Office Action Summary

10/595,543

TAKABATAKE

FIG. 6
PRIOR ART

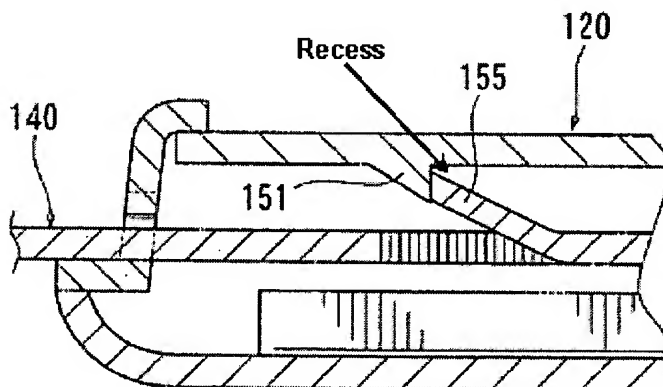
Re claim 9, applicant's admitted prior art discloses a vehicle sun visor comprising an extendable plate (140), a visor body (120), wherein the extendable plate is slidably movable within the visor body between a first position and a second position, a first removal-preventing member (151), a second removal-preventing member (152), a recess wall surface formed by one of the first removal-preventing member or the second removal-preventing member (see the figure below), wherein the extendable plate includes one of the first removal-preventing member or the second removal-preventing member, wherein the visor body includes the other of the first removal-prevention member or the second removal-preventing member, wherein a tip of one of the first removal-preventing member or the second removal-preventing member engages the recess wall surface when the extendable plate is in the second position.

Re claim 12, applicant's admitted prior art discloses a vehicle sun visor comprising an extendable plate (140), a visor body (120), wherein the extendable plate is slidably movable along a lengthwise direction relative to and within the visor body between a first position and a second position, a first protruding member (151) orthogonal to the length wise direction, a second protruding member (152) orthogonal to the lengthwise direction, wherein one of the first protruding member or the second protruding member is integrated with an inner wall surface of the visor body, a removal-preventing recess formed by the one of the first protruding member or the second protruding member and the inner wall surface of the visor body, wherein an other of the first protruding member or the second protruding member is integrated with a surface of the extendable plate, wherein a tip of the other of the first protruding member or the second protruding member is inserted into the removal-preventing recess when the extendable plate is in the second position (see the figure below).
